This page lists the known errors on the gm5x5x5 PCBs. There are no known issues with the bulk order run (white PCBs), the following information is valid **only** for the prototype run (green PCBs).

## **Bulk Order #1 (white PCB, rev 1.0)**

## **Prototype Run**

### **#2 MISSING TRACK**

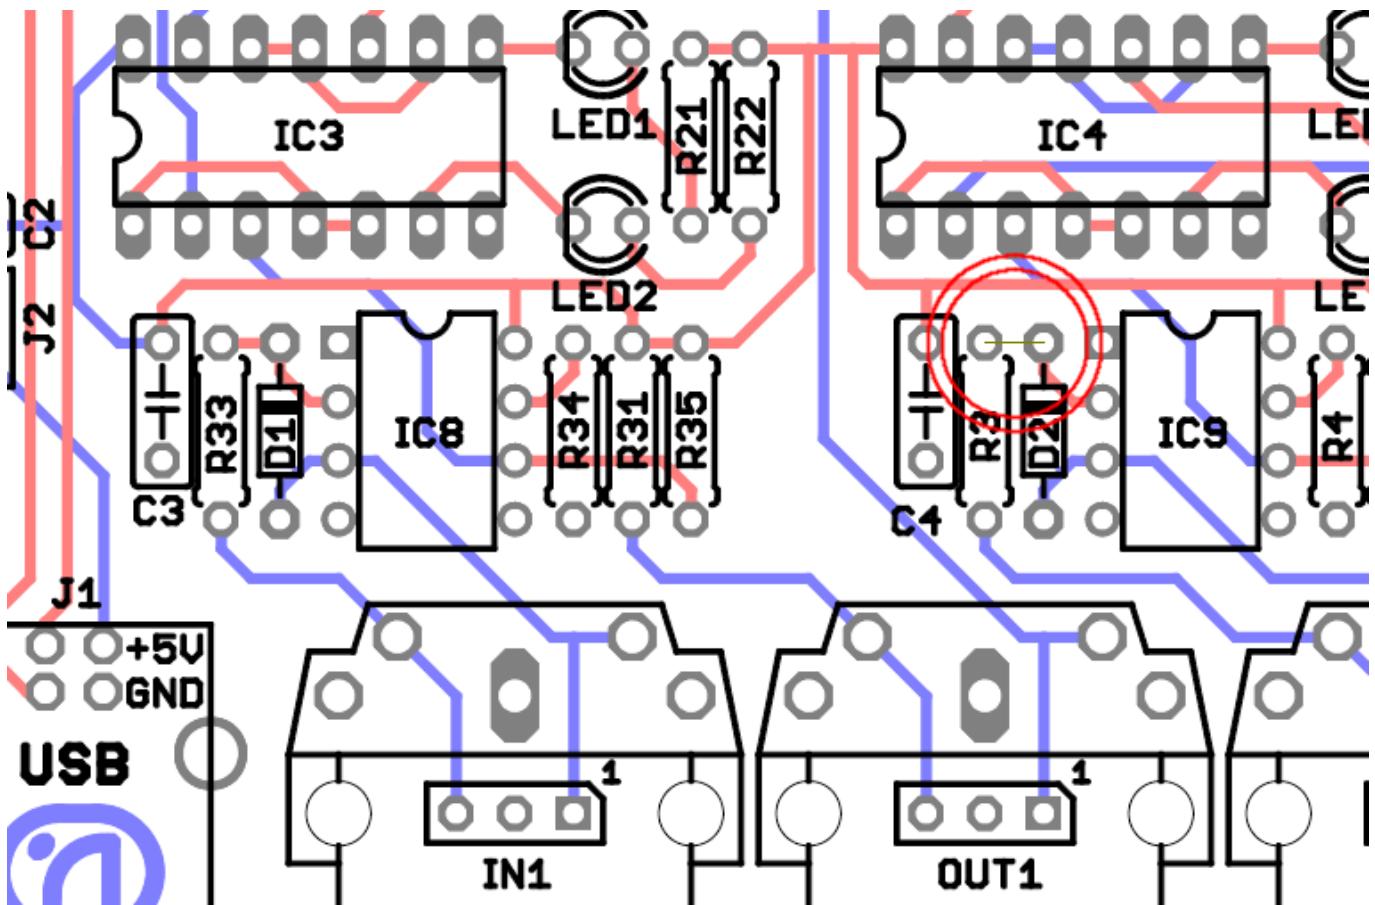
**Problem:** A track between D2 and R3 is missing.

**Solution:** Bridge the pins.
